Urgent Field Safety Notice
Product Correction
 Urgent - Immediate Action Required

Date Issued September 16, 2019

Abbott has identified a potential reliability issue with the Alinity ci-series Level Sensor, Bulk Solution (LN 04S68-02). The details of the issue and the potential impact is described below.

Figure 1. Examples of cracked level sensor (Not Acceptable)

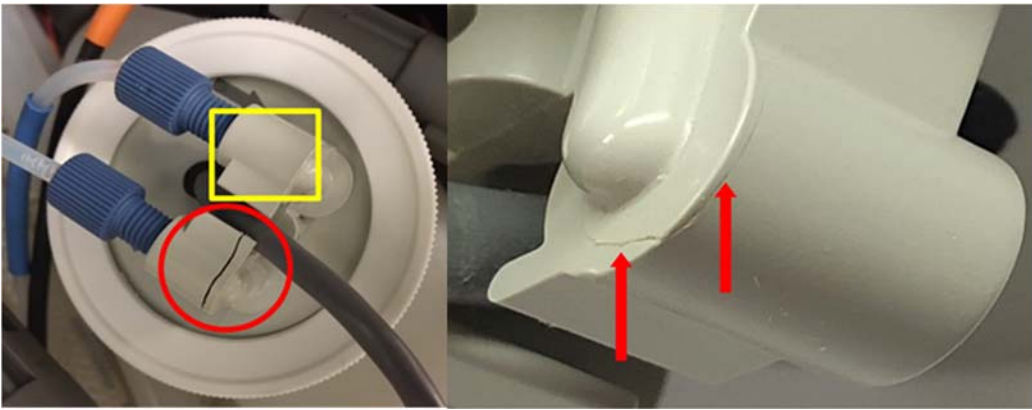
- Crack size and location on inlet and outlet ports is variable. See Figure 1.
 - On each level sensor, there is a “knit” line that is a normal outcome from the manufacturing process. The “knit” line is not a crack or defect in the level sensor. See Figure 2.
4. If crack(s) are detected,
 - Replace the bulk level sensor. LN 04S68-02 may be used until LN 04S68-03 is available. For replacement instructions, refer to the Alinity ci-series Operations Manual, Section 9.
 - Review results generated from the last successful quality control.
 5. When the inspection is complete slide the reservoir bottle tray into the bulk solution reservoir area and close the bulk solution door.

- Area in red circle indicates level sensor crack.
- Area in yellow square indicates undamaged port.
- Area with red arrows indicates cracks.

Figure 3. Identification of the Level Sensor, Bulk Solution (LNs 04S68-02 and 04S68-03)

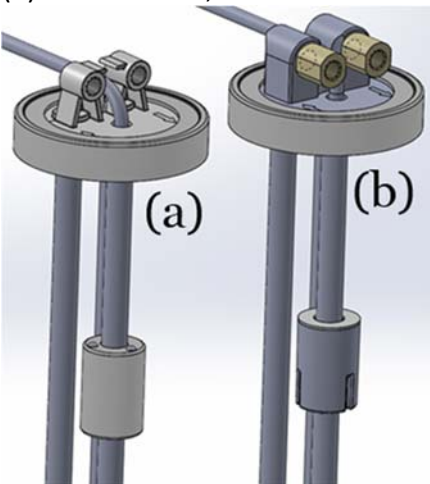
Abbott has redesigned Level Sensor, Bulk Solution (LN 04S68-02) to improve reliability. The redesigned Level Sensor, Bulk Solution (LN 04S68-03) will be available beginning in the fourth quarter of 2019. You may continue to run the system using part number (LN 04S68-02) until the replacement parts (LN 04S68-03) are obtained by taking the recommended actions outlined in this letter. Once the redesigned Level Sensor, Bulk Solution (LN 04S68-03) is available, Abbott recommends the replacement of the LN 04S68-02 in all positions on the Alinity c and i systems.

The development of environmental stress on the bulk solution level sensor can cause cracks. Cracks can allow air to enter the fluid line, which may result either a failure to dispense or an incomplete dispense of the bulk solution on Alinity i and Alinity c.

(a) Level Sensor, Bulk Solution LN 04S68-02, (b) Level Sensor, Bulk Solution LN 04S68-03
